Area Walk-By Checklist (AWC)

Area 14 - AB2, EL. 587', Room 40

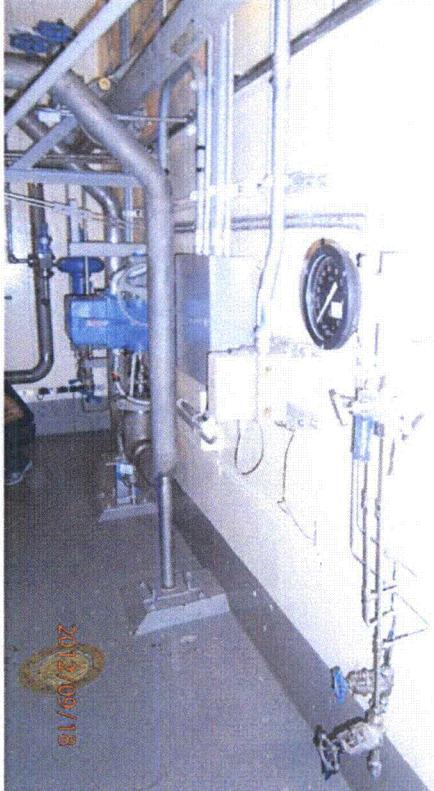
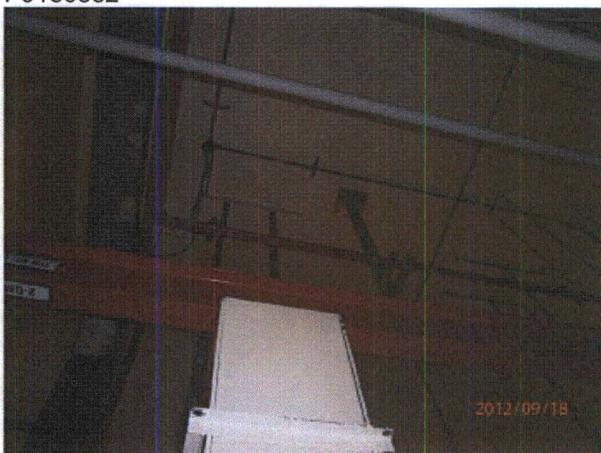
2. Does anchorage of equipment in the area appear to be free of significant degraded conditions?
Pipe support downstream of 2-SI-115S warped by bottom left bolt - Integrity of pipe support should be evaluated. No

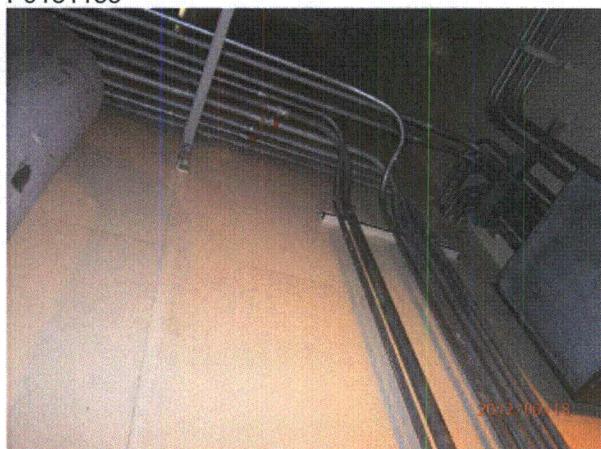
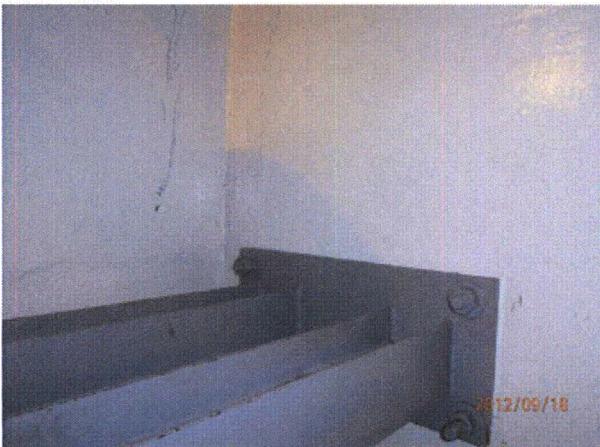
8. Have you looked for and found no other seismic conditions that could adversely affect the safety functions of the equipment in the area? Yes
2-ICM-321 outlet downstream pipe support bottom left corner bolt spalled concrete - AR#0115039 and WO#55060450, previously evaluated for Use-As-Is.

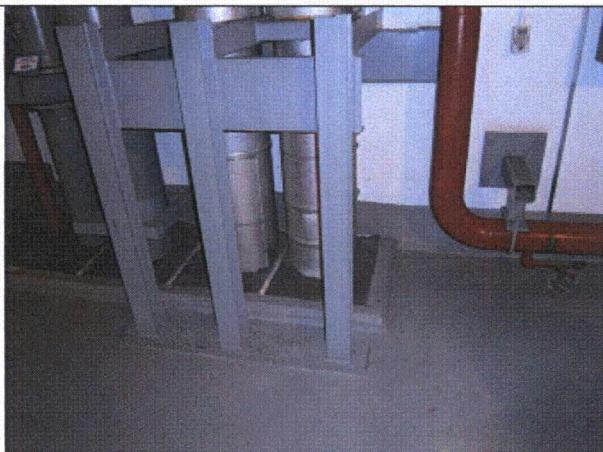
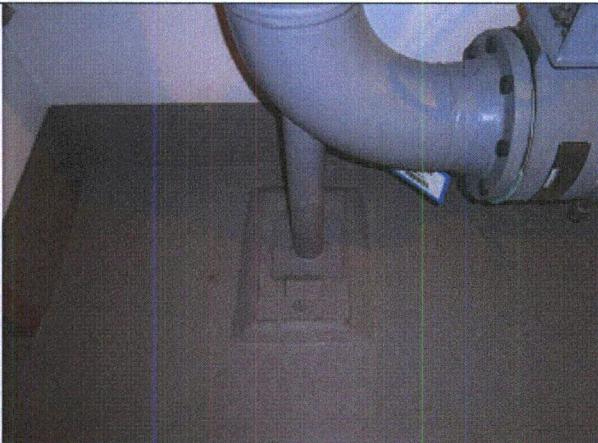
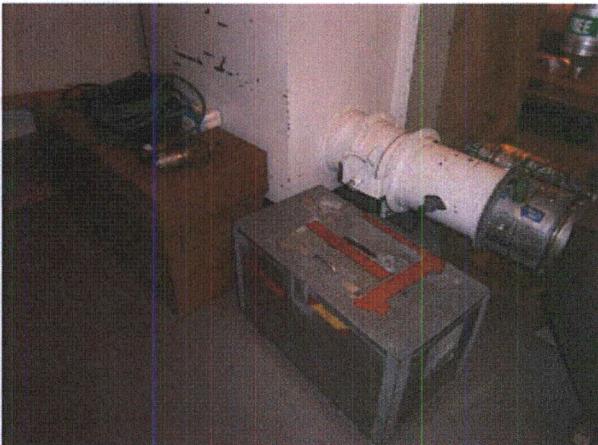
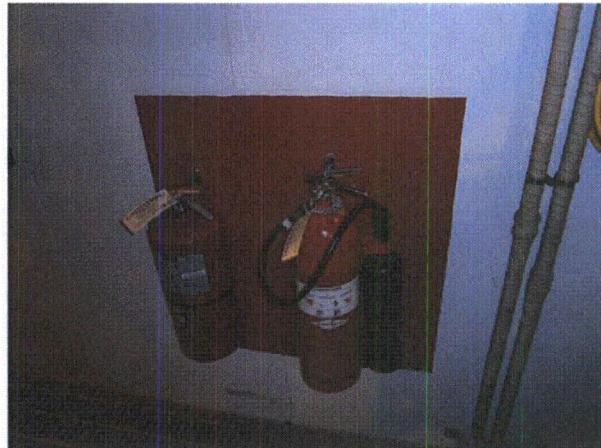
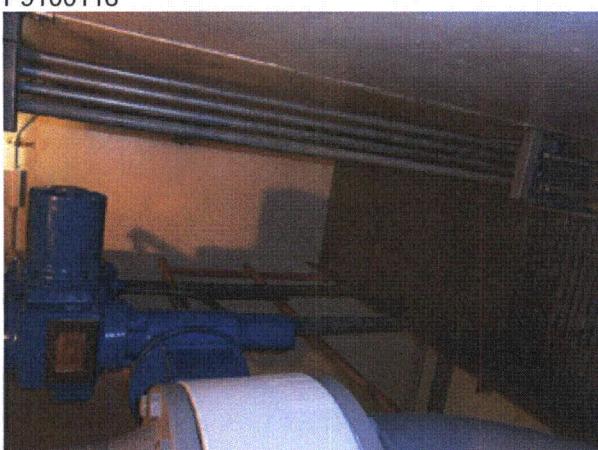
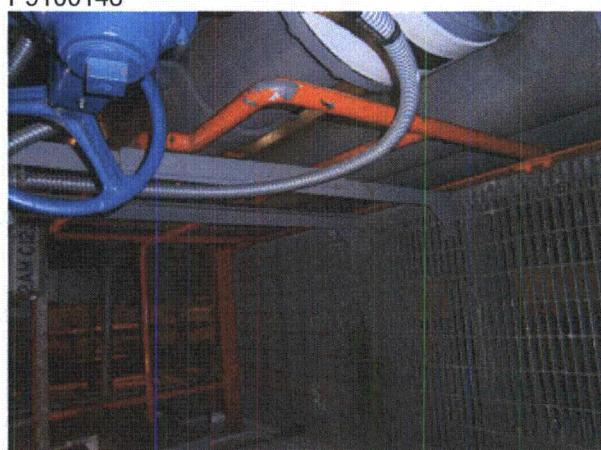
4. Does it appear that the area is free of potentially adverse seismic spatial interactions with other equipment in the area (e.g., ceiling tiles and lighting)? No
Fire extinguishers on short hooks by General area between 2-WMO-715 and 2-CFI-429 - AR 2012-11669 was issued.

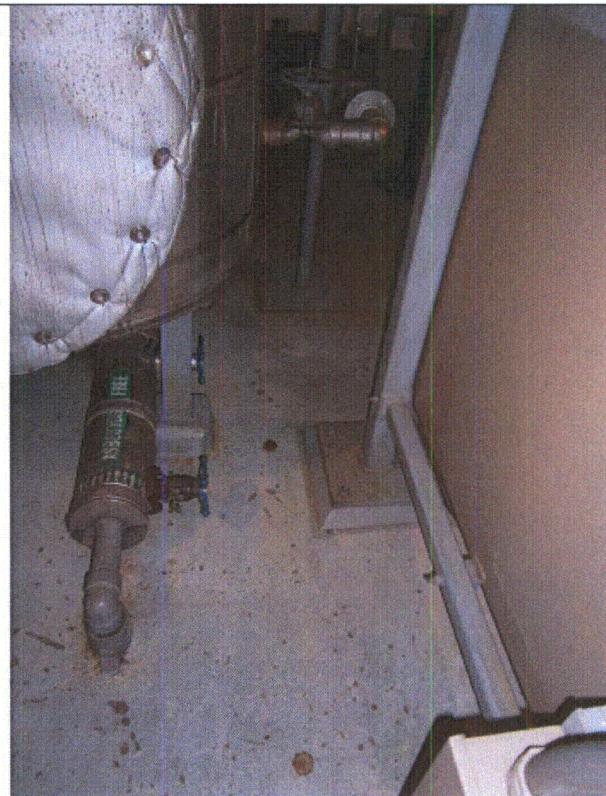
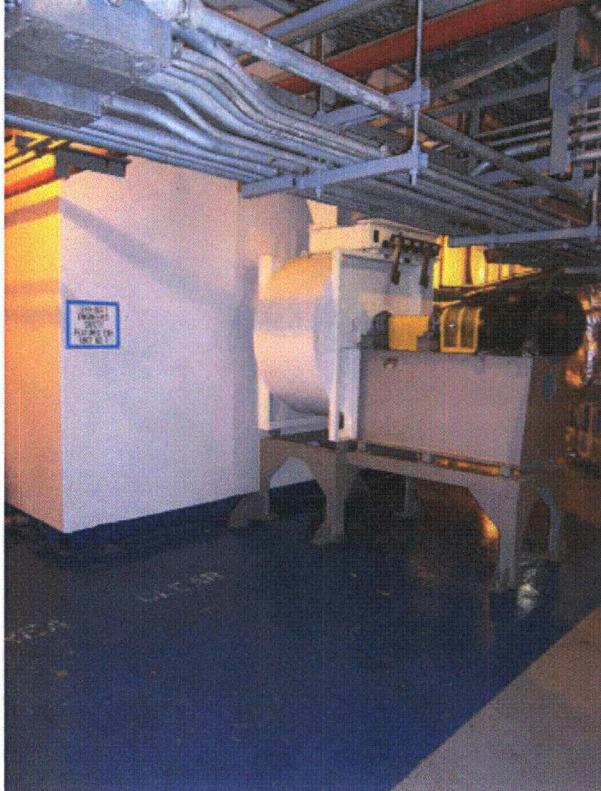
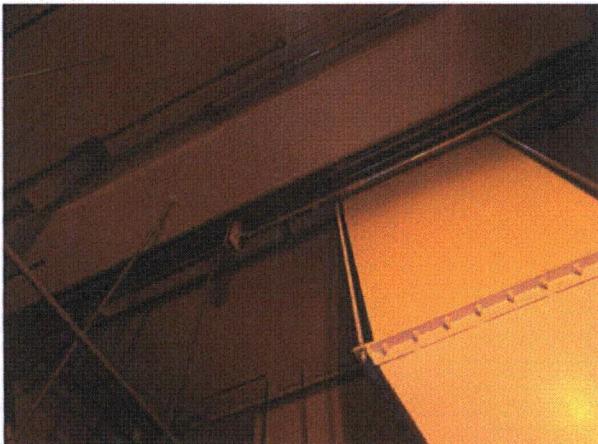
4. Does it appear that the area is free of potentially adverse seismic spatial interactions with other equipment in the area (e.g., ceiling tiles and lighting)?
Fire extinguishers on short hooks by MCCs - AR 2012-11669 was issued.
Block wall behind 2-HV-AES-1 AND 2-HV-AES-2 - OK per DWG 12-4029, Wall W-7. No

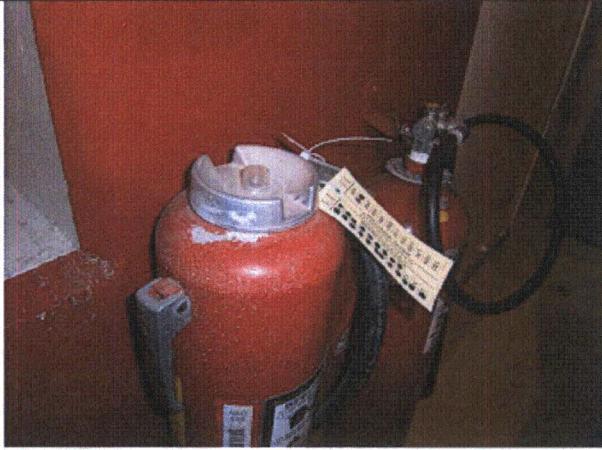
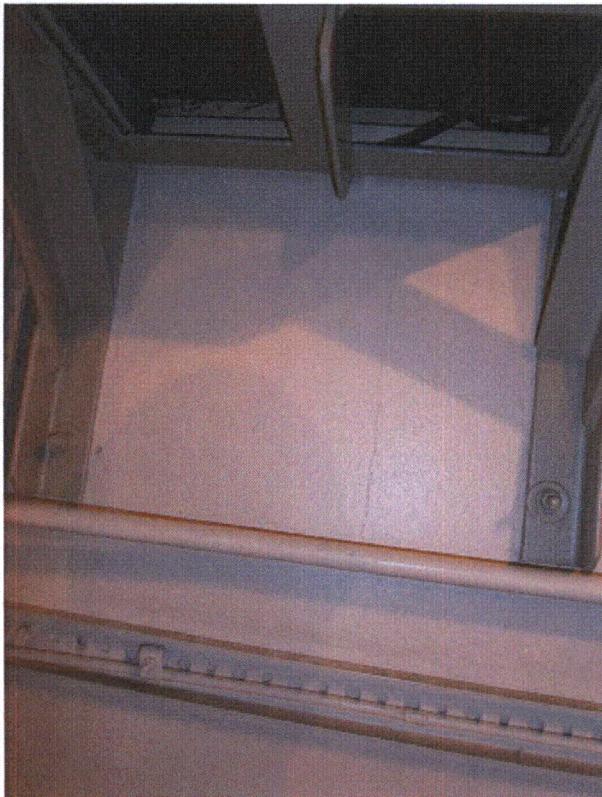
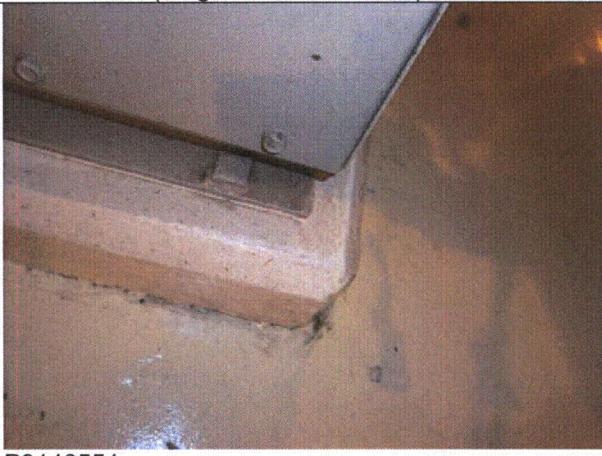
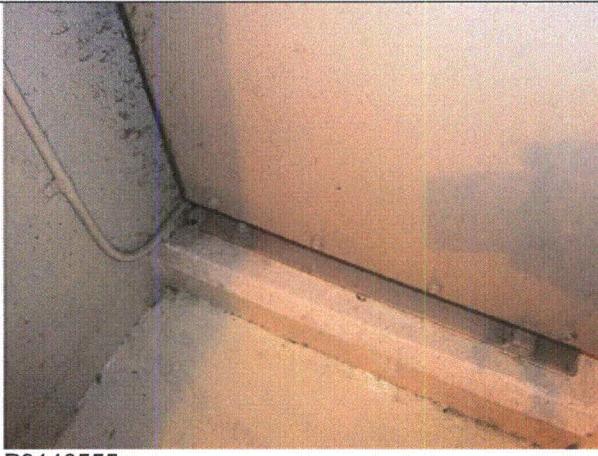
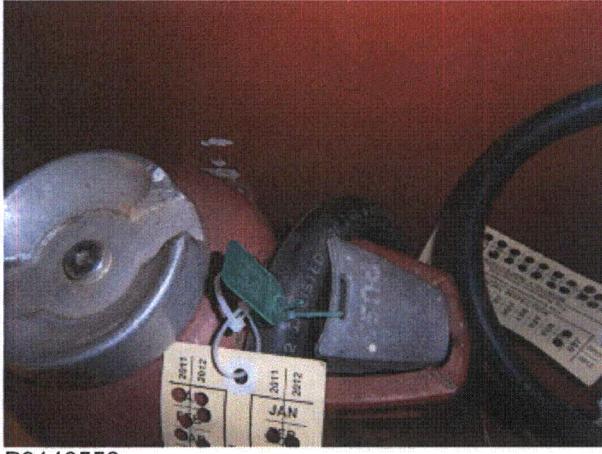
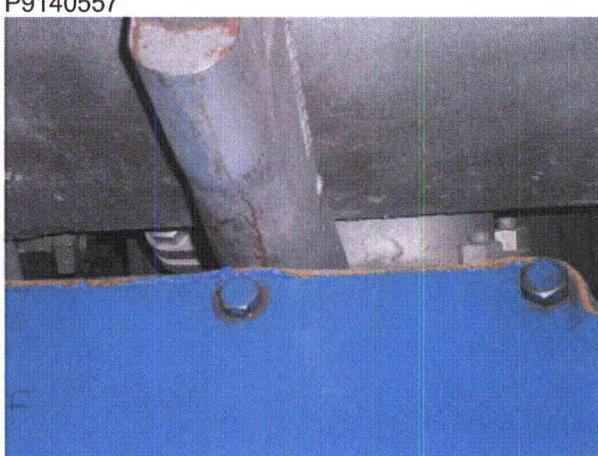
4. Does it appear that the area is free of potentially adverse seismic spatial interactions with other equipment in the area (e.g., ceiling tiles and lighting)?
Fire extinguishers on short hooks - AR 2012-11669 was issued. Block wall on left side of room - OK per DWG 2-4036, Wall W-1 and Wall-W2. No

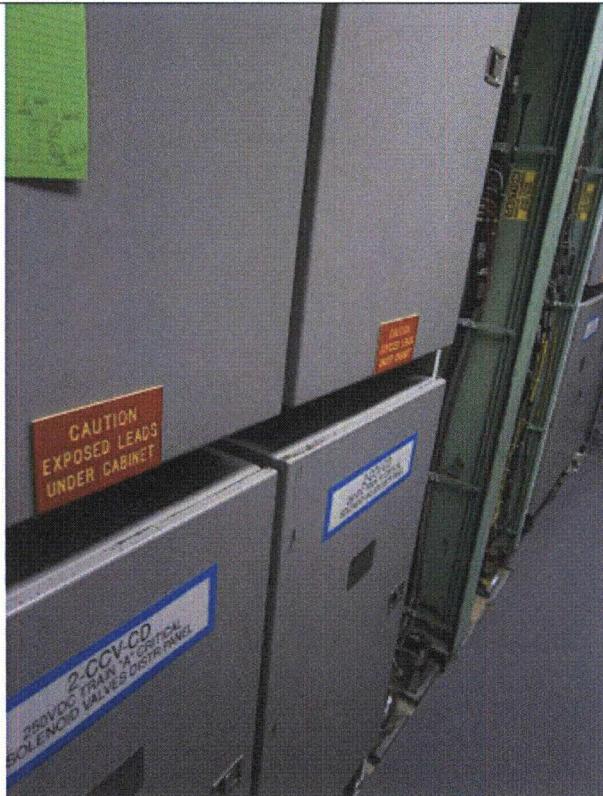
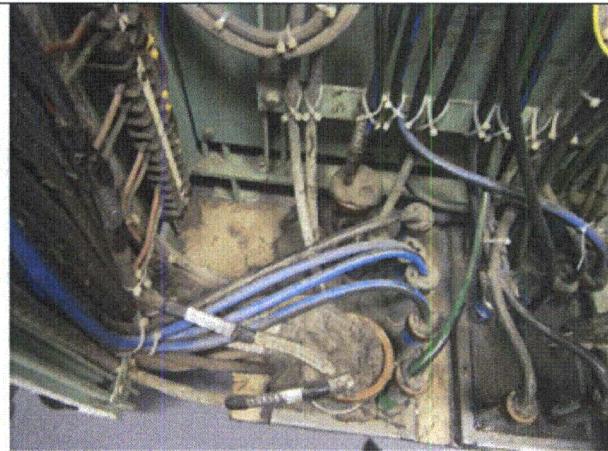
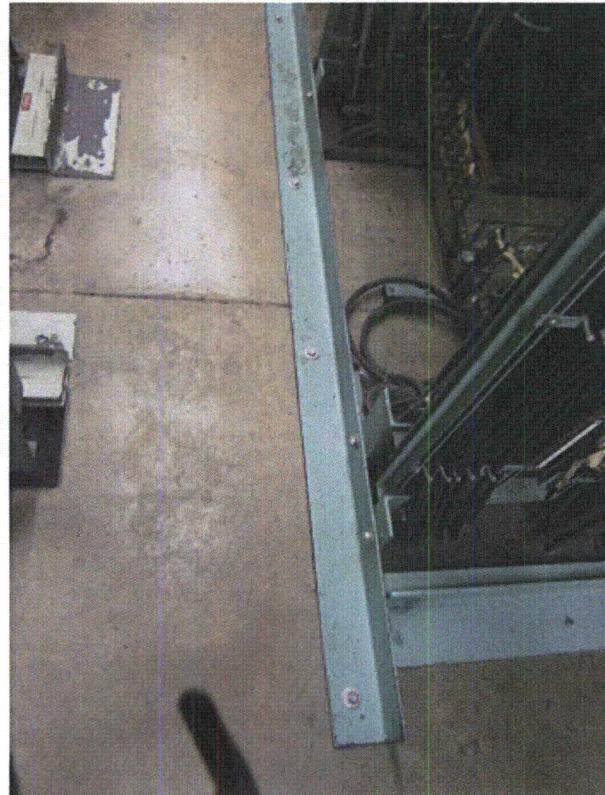
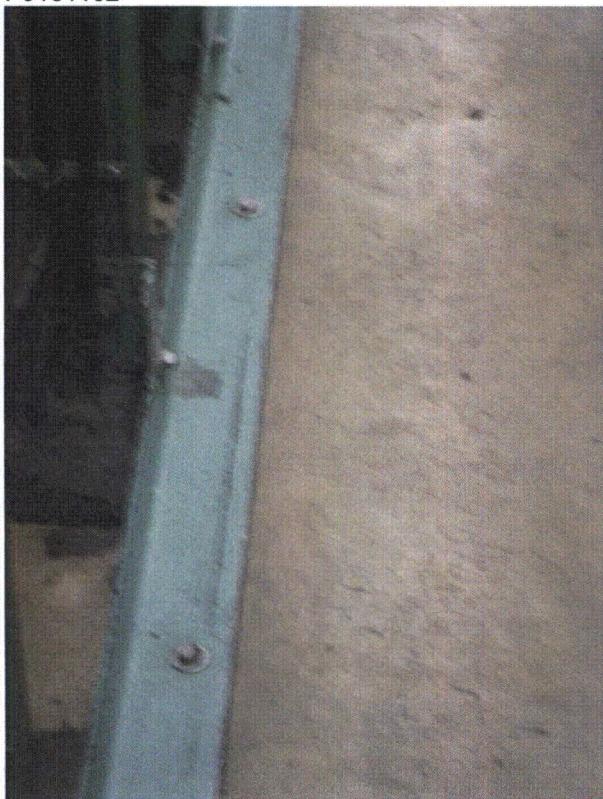
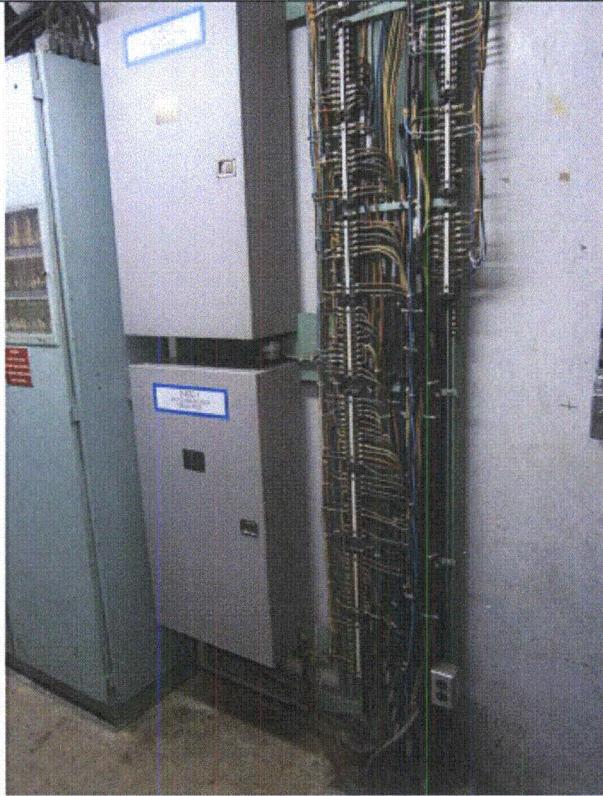
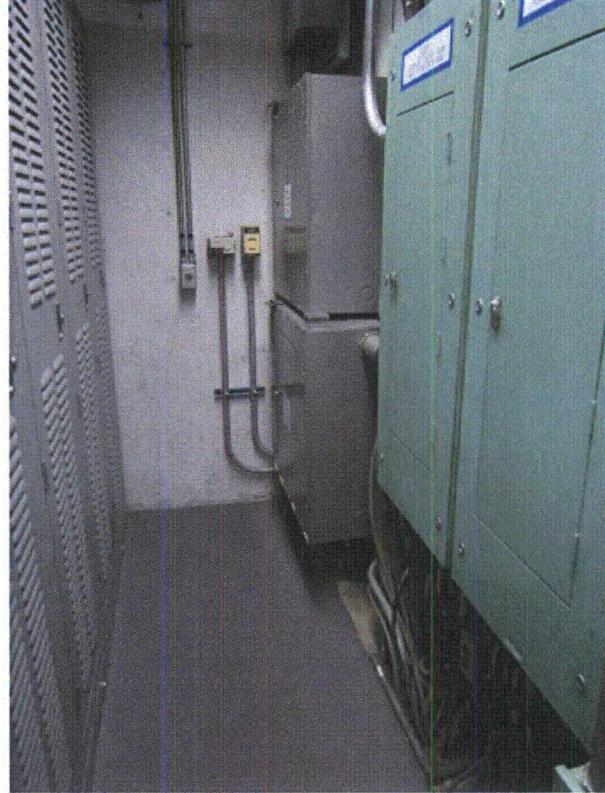
7. Does it appear that the area is free of potentially adverse seismic interactions associated with housekeeping practices, storage of portable equipment, and temporary installations (e.g., scaffolding, lead shielding)?
Fire extinguishers mounted to side of control panels (seismic hooks, but can be an interaction) - Addressed in AR 2012-11730. Big Emergency cart with 4 chocked wheels - small procedure cart chained off to it (no chocked wheels) and TOO CLOSE TO PANEL - Addressed in AR 2012-11726. No

8. Have you looked for and found no other seismic conditions that could adversely affect the safety functions of the equipment in the area? Yes
Between 2-NIS-1 and IV panel there are missing bolts connecting the two panels together, but nuts are there (between 2 panels) - needs investigation - AR 2012-11726 was issued to investigate found conditions.
